Detailed Site Plan Alternative Compliance Clinton Market Place North

DSP-23006
AC-23005

STAFF REPORT

SUBJECT: Detailed Site Plan DSP-23006
Alternative Compliance AC-23005
Type 2 Tree Conservation Plan TCP2-015-14-02
Waiver from Section 25-128(b)
Clinton Market Place North

Figure 1: Detailed Site Plan

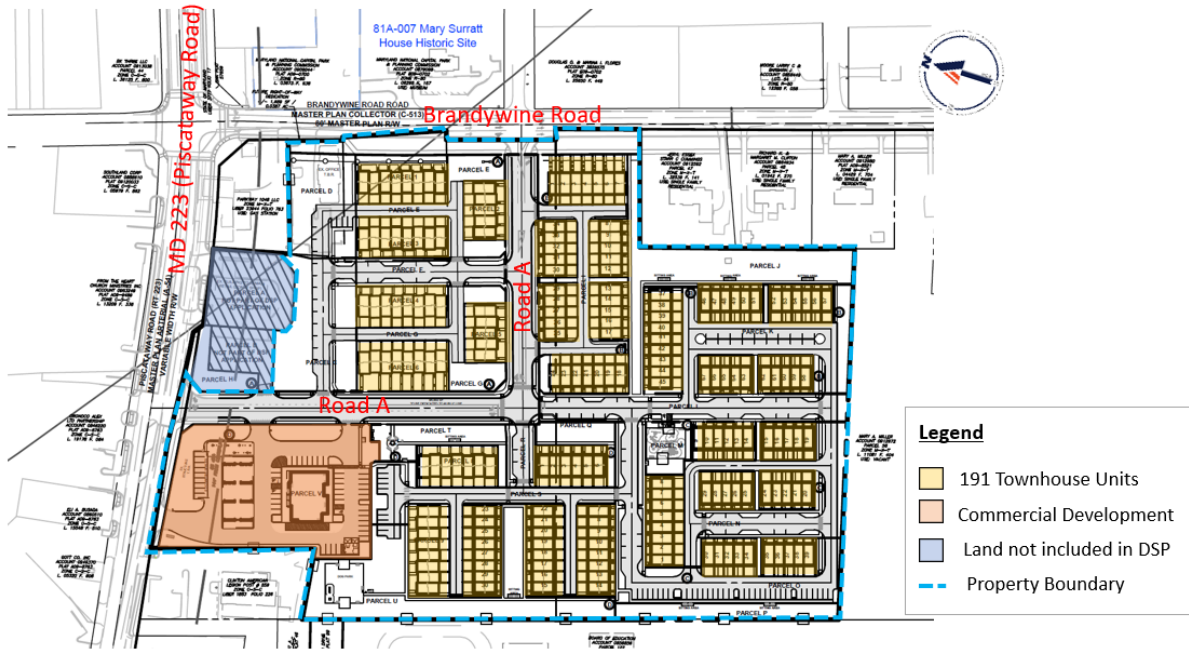
- d. Various sitting areas located throughout the site. A condition is included herein requiring the applicant to correct the permit timing for this facility on the coversheet and Sheet 8 of the landscape plans, since the number of townhouse units proposed by this DSP is 191. The submitted plans show that no sitting areas are provided in the northeast quadrant of Road A. A condition is included herein requiring the applicant to provide at least two seating areas along Alley 13.

The subject DSP includes one loading space and one dumpster for the proposed food or beverage store and gas station. Since the loading space directly faces the vehicle access point on MD 223 to this commercial development, a condition is included herein requiring the applicant to expand the planting island located at the northwest corner of the food or beverage store building, with additional plantings, to shield this loading space from the public view on MD 223. The submitted plans also show the location of the proposed trash dumpster, with details of the dumpster enclosure. The dumpster is screened with a dumpster enclosure that is approximately 8 feet in height.
